D206-667-247TRN
Job Sheet 165930

Part Name: Crosstube Assembly, Mid Aft

DRAWING NO. D206-667-247	TITLE CROSSTUBE ASS'Y (206L MID AFT)	REV. A	DART AEROSPACE LTD ENGINEERING ORDER		D.E.O. NO. D206-667-247-A-1	SHEET NO. SHEET 1 OF 1	SCALE NTS
DRAWN <i>q2</i>	CHECKED <i>ASS</i>	MFG. APPR. <i>KB</i>	APPROVED <i>JMP</i>		DE APPR. <i>th</i>		
DATE 11.07.15	DATE 11.07.20	DATE 11.07.21	DATE 11/07/21		DATE 11.07.21

PURPOSE:

DART AEROSPACE LTD HAWKESBURY, ONTARIO, CANADA	
DRAWING NO. D206-667-247	REV. A SHEET 1 OF 4
TITLE CROSSTUBE ASSY (206L MID AFT)	SCALE NTS

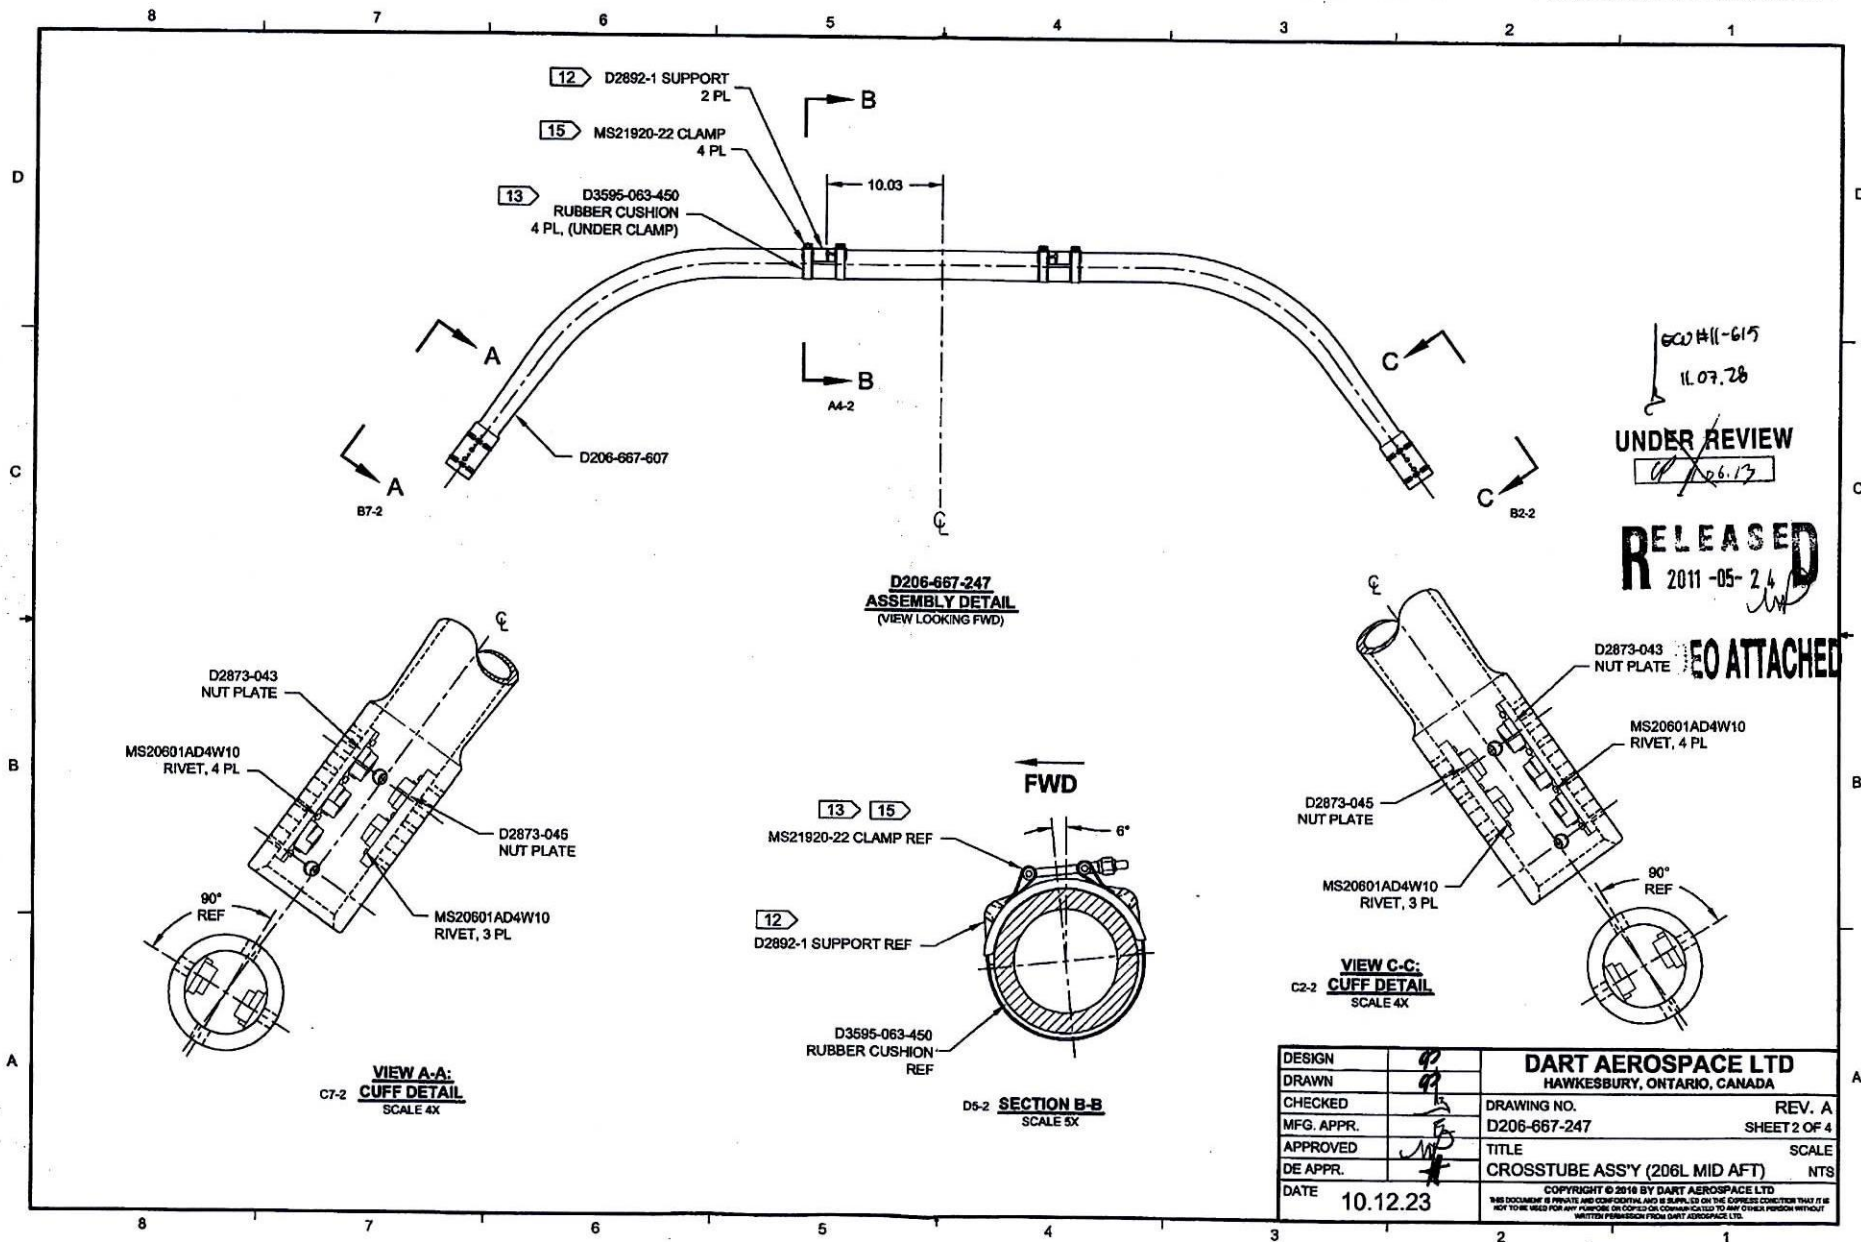
REPLACE MAGNOBOND WITH PROSEAL.

NOTE 12 & 15, SHEET 1 IS AMENDED AS FOLLOWS:

- 12) INSTALL D2892-1 SUPPORT USING 0.03" TO 0.06" THICK LAYER OF MAGNOBOND 6398 PER QSI 015. LET CURE FOR 12 HOURS AFTER INSTALLATION AND PRIOR TO PACKAGING.
- 15) TORQUE CLAMPS 80 TO 100 IN-LB. ENSURE AT LEAST 1.5 THREADS SHOWING IN SAFETY AND THAT NUT HAS NOT BOTTOMED-OUT AFTER TORQUING.

- 12) TO INSTALL D2892-1 SUPPORT: ABRAD MATING SURFACE OF SUPPORT AND CROSSTUBE WITH 180-GRIT SANDPAPER AND REMOVE RESIDUE WITH MEK (OR EQUIVALENT). APPLY A 0.04" TO 0.07" THICK LAYER OF PROSEAL 890 CLASS B-2 (OR AMS-S-8802 CLASS B-2) SEALANT TO MATING SURFACE OF SUPPORT.
- 15) TORQUE CLAMPS 80 TO 100 IN-LB. ENSURE AT LEAST 1.5 THREADS SHOWING IN SAFETY AND THAT NUT HAS NOT BOTTOMED-OUT AFTER TORQUING. **PRIOR TO PACKAGING, RE-CHECK TORQUE ON CLAMPS AFTER PROSEAL 890 SEALANT HAS CURED FOR 72 HOURS.**
